2020 Inundation Study and Dam Safety Review Final Report

Bear River Control Structure

City of Grande Prairie

July 16, 2021

Figure 4.1 Locations for Tree/Bush Removal

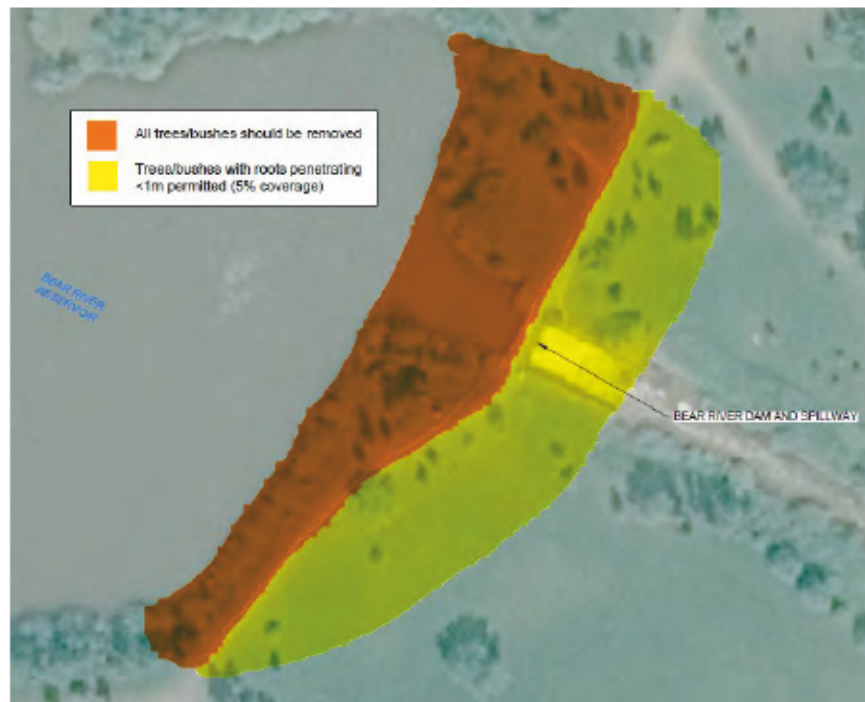
- › There are a number of trees and bushes growing on the upstream slopes, crest, and downstream slopes of the dam. The trees (particularly the large deciduous trees) and bushes on the dam should be removed at some point in the next few years. **Figure 4.1** shows the areas where the trees and bushes should be removed. All trees and bushes should be cleared from the area highlighted in orange. Trees and bushes with root structures that penetrate less than 1 m into the dam are permitted in the area highlighted in yellow, with coverage of less than 5% of the total area recommended.

Figure 9.6 Middle Trunnion Concrete Block (Sameng 2010)

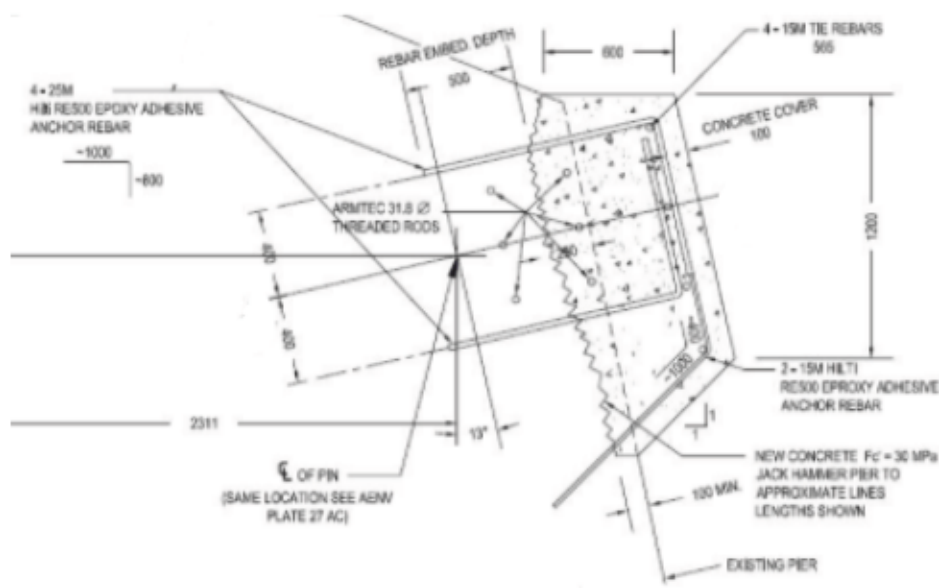
- › Considering that the gates are maintained partially open as part of normal winter operation of the Bear River Control Structure, the middle trunnion concrete block has sufficient strength to resist trunnion force resulting from the ice load estimated using the CEATI Ice Loading Model on the partially open gates. Site specific measurements are recommended to confirm the ice loads considered in the present assessment. It is anticipated that any change in gate operation during winter would also consider the corresponding change in trunnion load and safety of the trunnion block should be reviewed.

In the original design of radial gate trunnion support at the middle pier, the trunnion pin was placed through the pier and trunnion loads were transferred to the upstream bottom end of the pier by using an anchor block along with inclined anchors. When the gates were replaced in 2010, the arms of the new gates were slightly longer, and the trunnion location was downstream of the original location. The new trunnions were attached to the side of the pier, which was locally extended and reinforced on the downstream side. The relevant documents made available to SNC-Lavalin as part of this mandate - Bear River Spillway Radial Gate Replacement As-Constructed Report – provide some details of the pier extension/trunnion block and one drawing (from Sameng) also shows the size and reinforcement details for the new trunnion block. Design calculations or criteria used for transferring the new trunnion loads to the pier are, however, not available. The Sameng drawing shows that the new concrete block was attached to the middle pier using 4-25M and 2-15M HILTI RE500 epoxy adhesive anchor rebars with embedment depth of 500 mm, as shown in **Figure 9.6**.
